BUILDING CODE OF AUSTRALIA COMPLIANCE ASSESSMENT REPORT

RPAC REVIEW FOR ST CATHERINE's SCHOOL

26 ALBION STREET, WAVERLY NSW 2024

REPORT NO. ► 5053 REV # 05

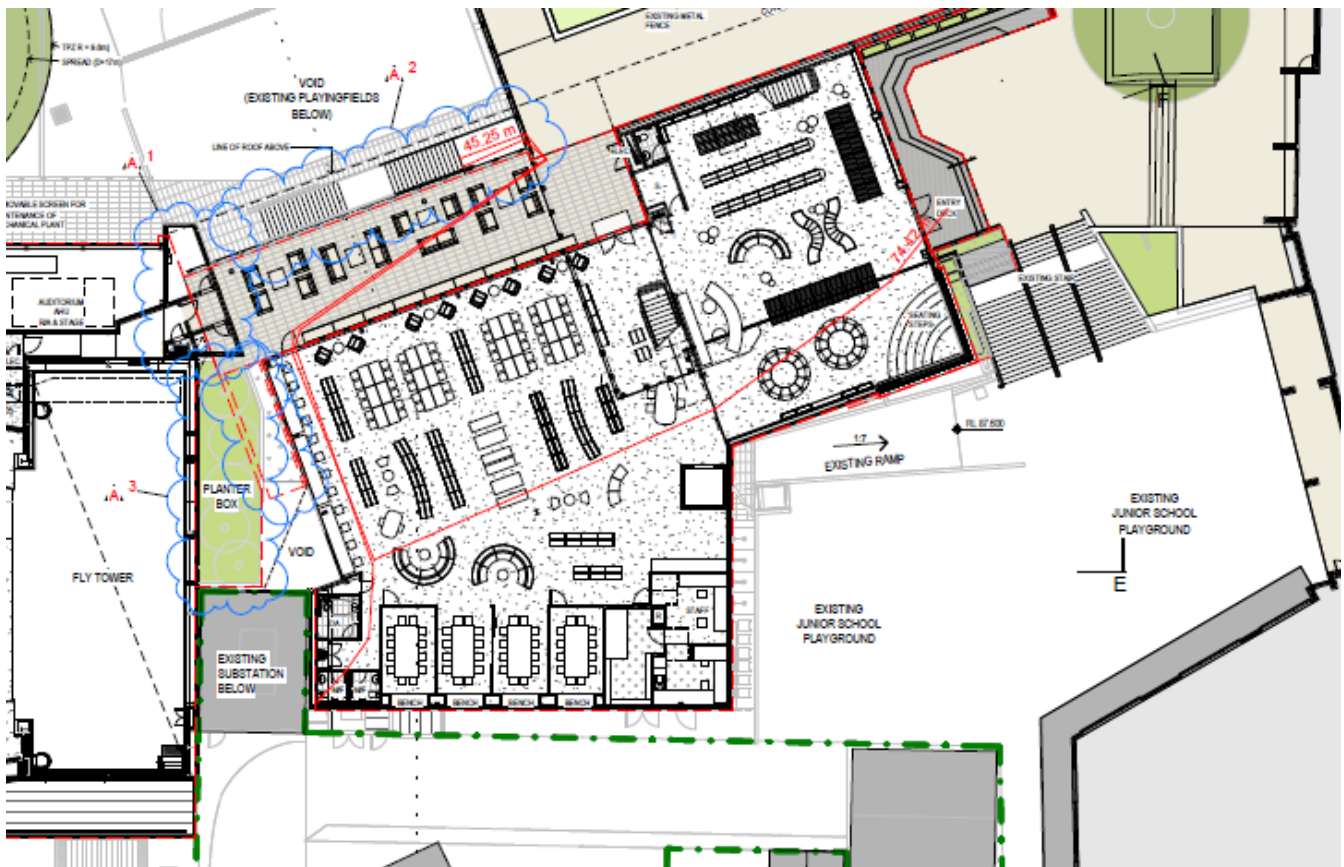
BCA Clause	Deemed-to-Satisfy Provision to be addressed
D1.5 Distance between alternative exits	<p><u>Compliance issues:</u></p> <ul style="list-style-type: none"> The distance between alternative exits on level 2 (measured around the east side of the swimming pool) is approximately 65-m in lieu of 60-m maximum i.e. between the door in the east façade and the stair up to level 3. A performance based solution is required to address this issue. The distance between alternative exits (measured via the point of choice) on level 1 is approximately 67-m in lieu of 60-m maximum i.e. between the two exits in the south façade when measuring via the point of choice for occupants egressing from the bike store on the east side. A performance based solution is required to address this issue. On level 6 phase B it is more than 60-m between exits, circa 75-m measured back via the point of choice, see below for a mark up on plan. This will need to be addressed via a performance based solution.
